Project Name: * Bridge 38 over Trent Creek

Revised utility permit drawings resulting from changes to utility relocation methodology though no changes to permitted impact totals.

Subject: **Modification Request for Section 10 Permit, Nationwide Permit 14, Section 401 Water Quality Certification and CAMA Major Development Permit** for the Proposed Replacement of Bridge No. 38 over Trent Creek on NC 55 in Pamlico County, North Carolina; TIP No. B-4593; WBS No. 42328.1.2

PERMIT DRAWING SHEET 2 OF 5

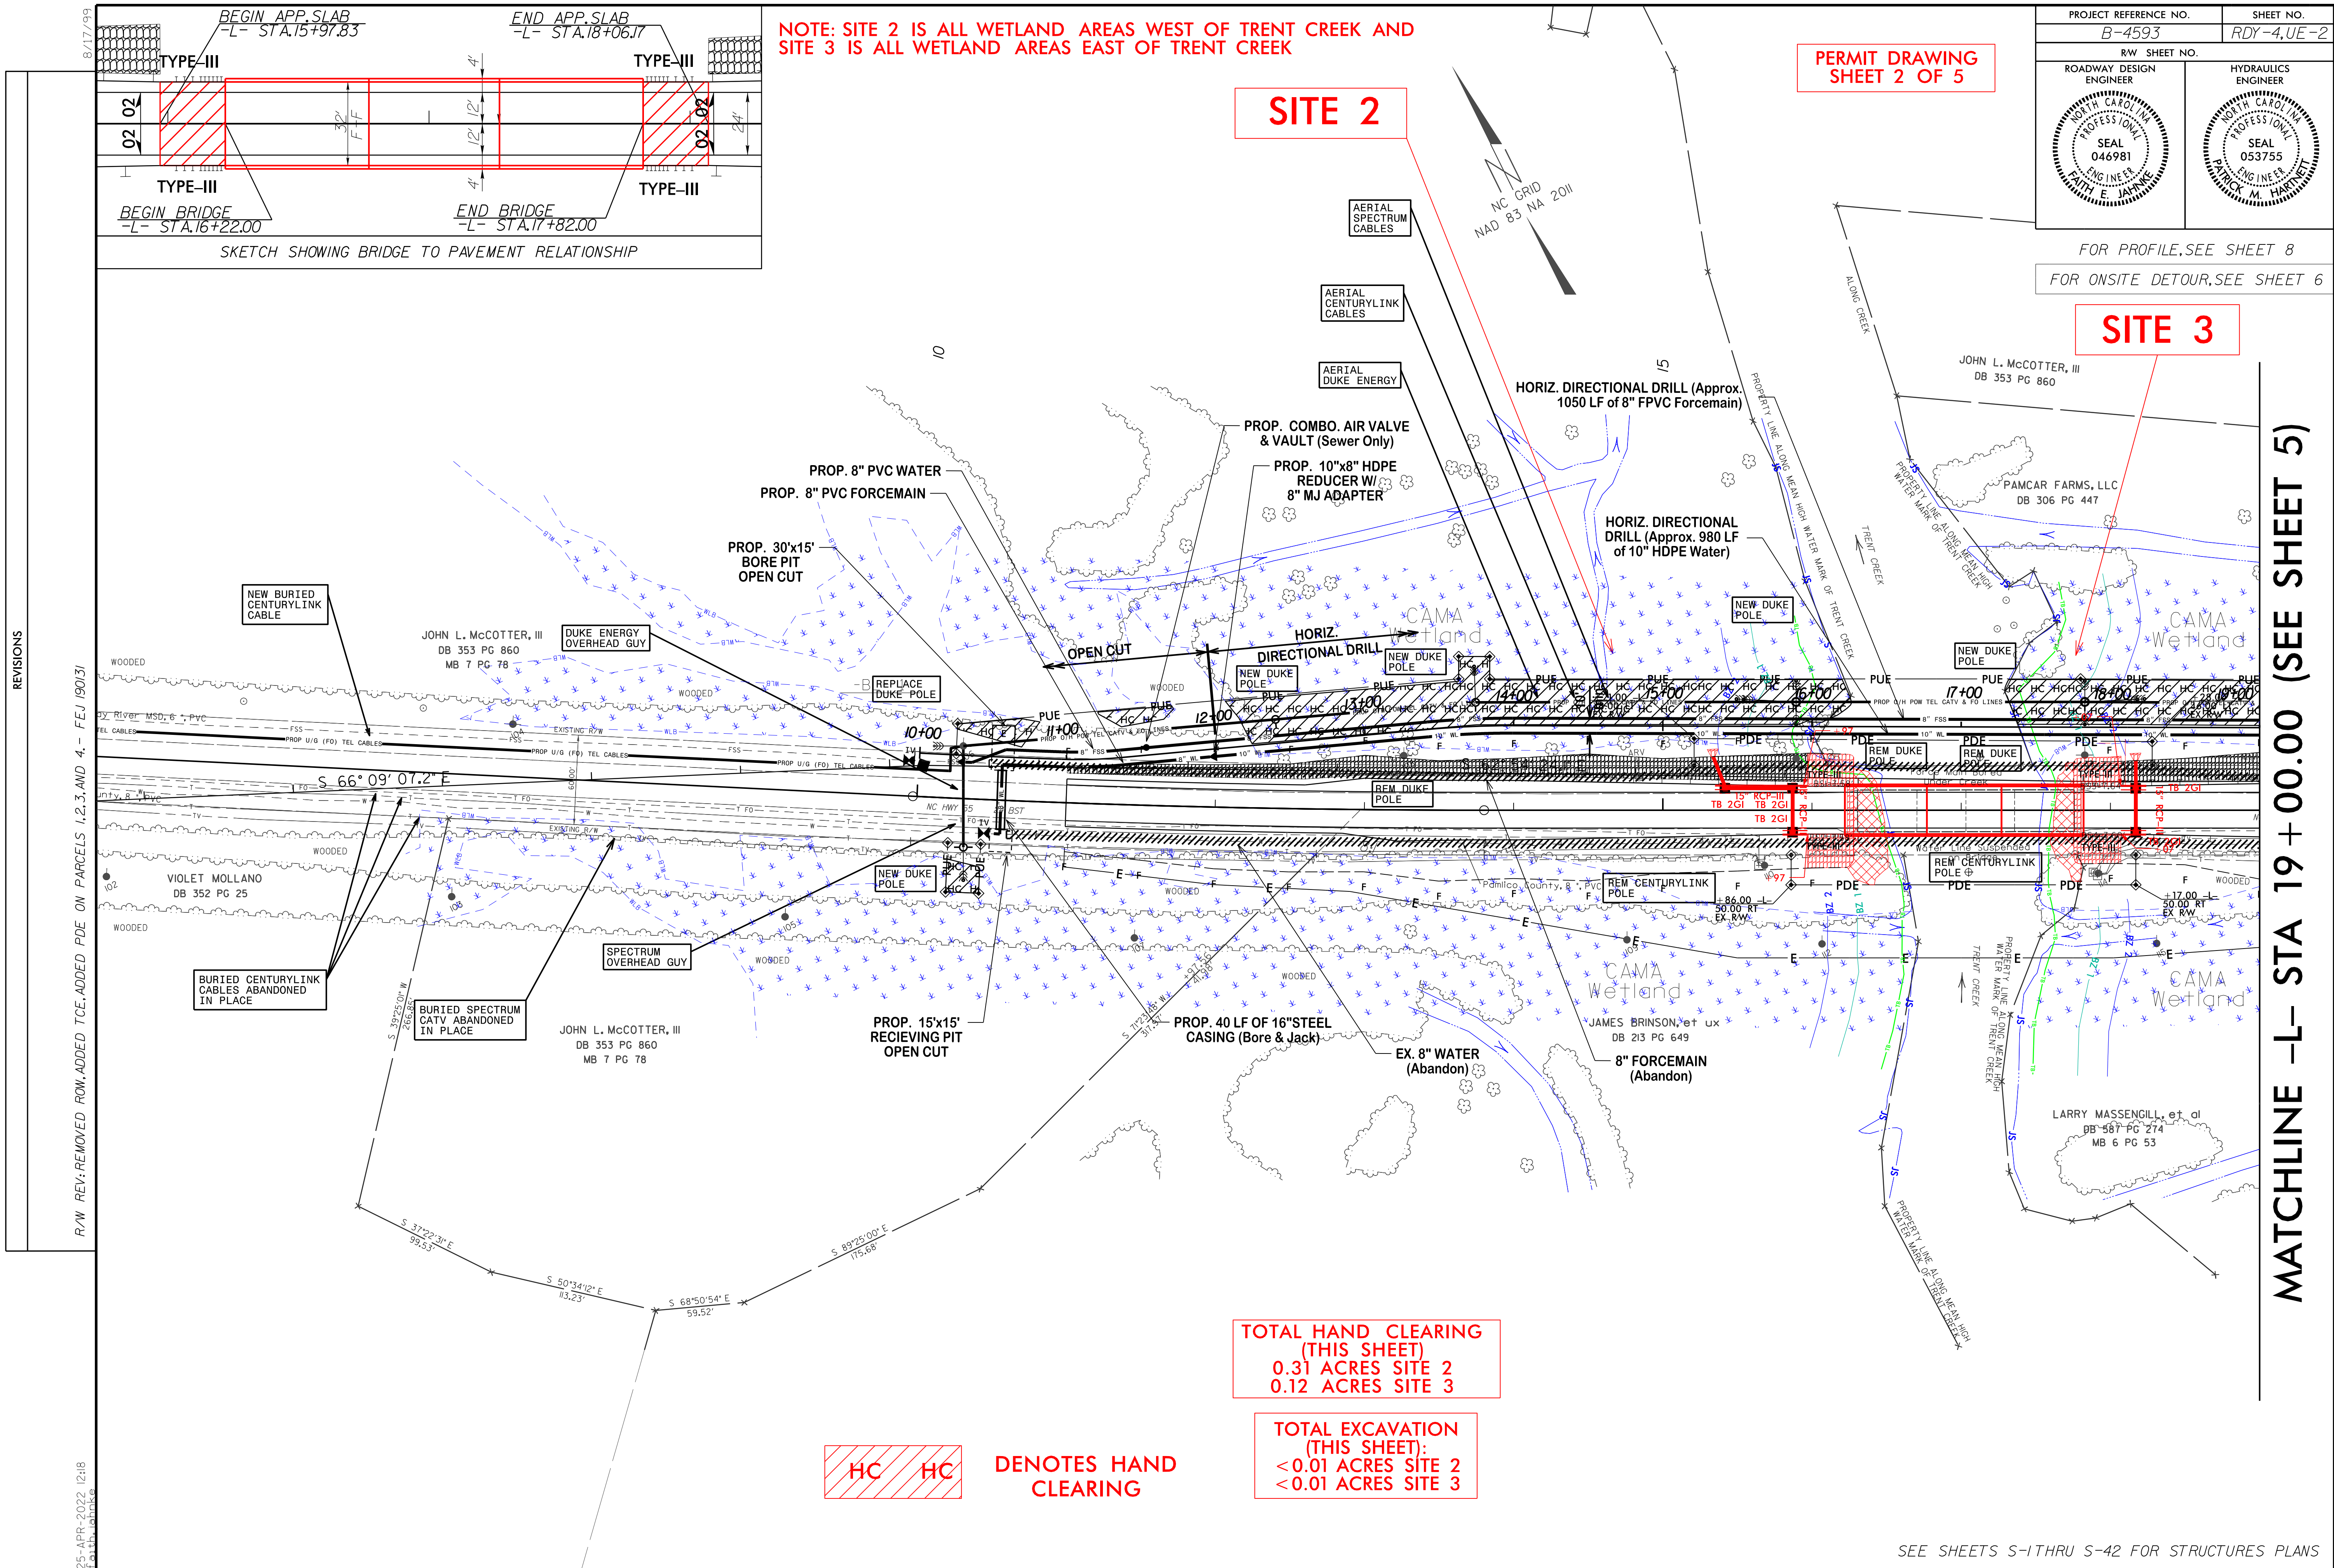
The Duke Energy section of the Utility narrative has been revised to describe their current plans. A new pole, pole 15, is proposed in wetlands and steel encasements are to be put around all the proposed poles. This results in a slight increase in impacts, from 15 square feet due to utility poles to 36 square feet.

Utility Permit Drawings were revised to depict the revised relocation plan and profile design files. The updated Utility Impact Summary Sheets are also provided however impact amount did not change (the additional 21 square feet of utility pole impacts amount to 0.00048 acre of impacts). Additional notes are listed on the Utility Impact Summary Sheet describing the excavation impacts in detail, and they total 0.016 acre, rounded to 0.02 in the spreadsheet which also remains unchanged.
